Re: FortisBC Inc. (FBC)

2021 Long-Term Electric Resource Plan (LTERP) and Long-Term Demand-Side Management Plan (LT DSM Plan) (Application) – Project No. 1599244

Response to the British Columbia Public Interest Advocacy Centre representing the British Columbia Old Age Pensioners' Organization, Active Support Against Poverty, Disability Alliance BC, Council of Senior Citizens' Organizations of BC, and the Tenant Resource and Advisory Centre *et al.* (BCOAPO) Information Request (IR) No. 2

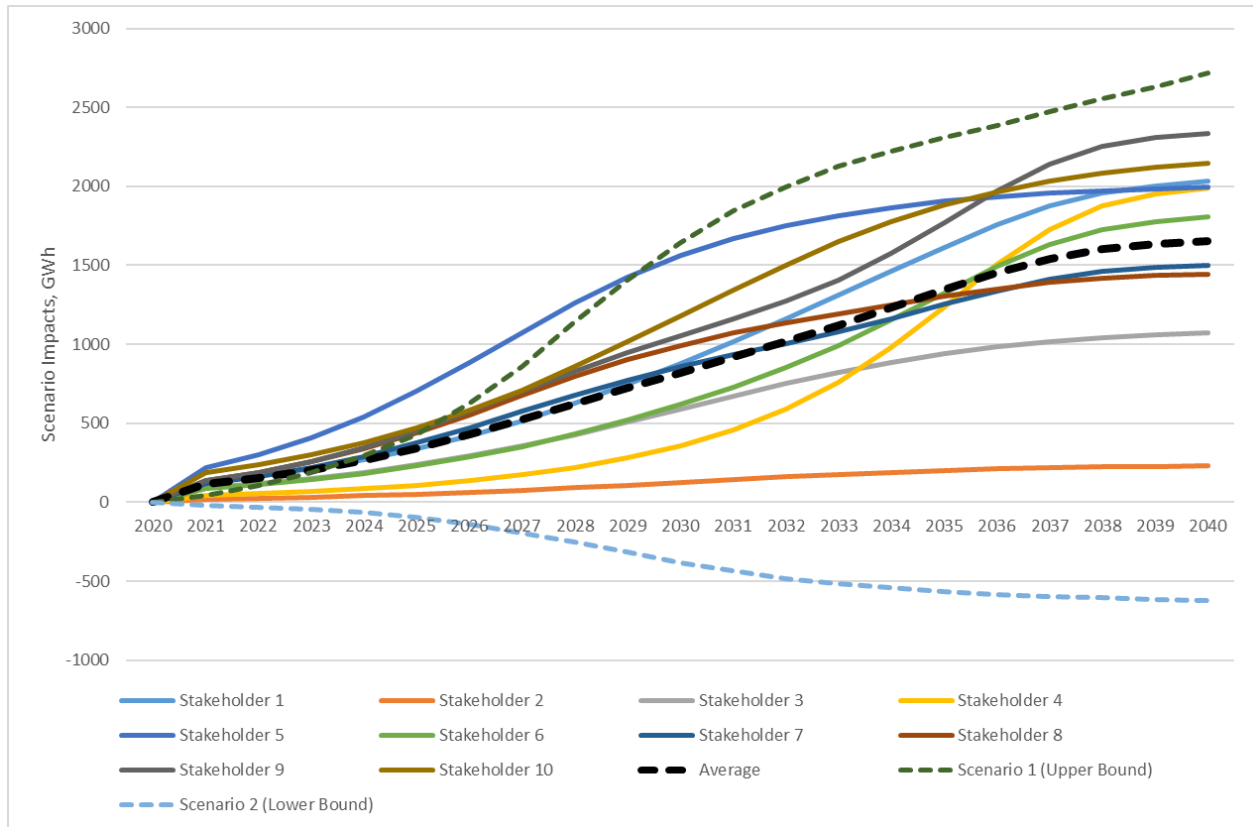
5 59.1 Please provide a revised version of Figure 4-5 that also includes the results from
6 Scenario 1 (Upper Bound) and Scenario 2 (Lower Bound).
7

9 The figure below is a revised version of Figure 4-5 that also includes the results from Scenario 1
10 (Upper Bound) and Scenario 2 (Lower Bound).

4 **Updated Figure 4-3**

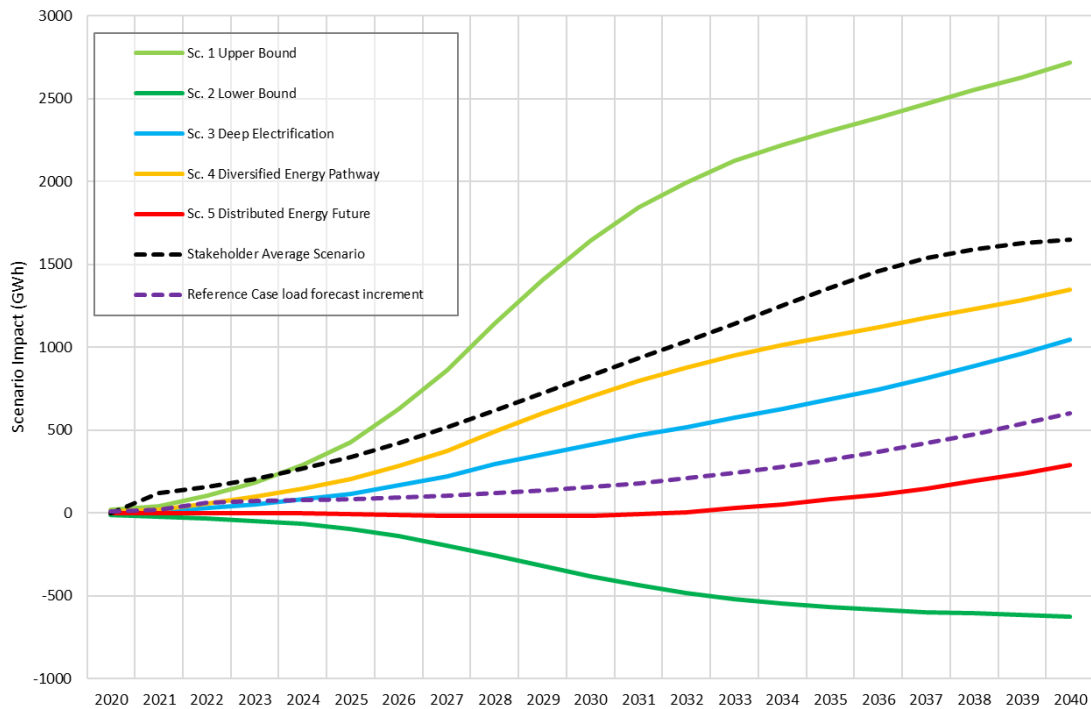
11
12
13
14
15 59.2 Please provide revised versions of Figure 4-3 and 4-4 that include the Reference
16 Load Forecast.
17

2 Updated Figure 4-3 below is a revised version of Figure 4-3 that also includes the Reference
3 Case load forecast.
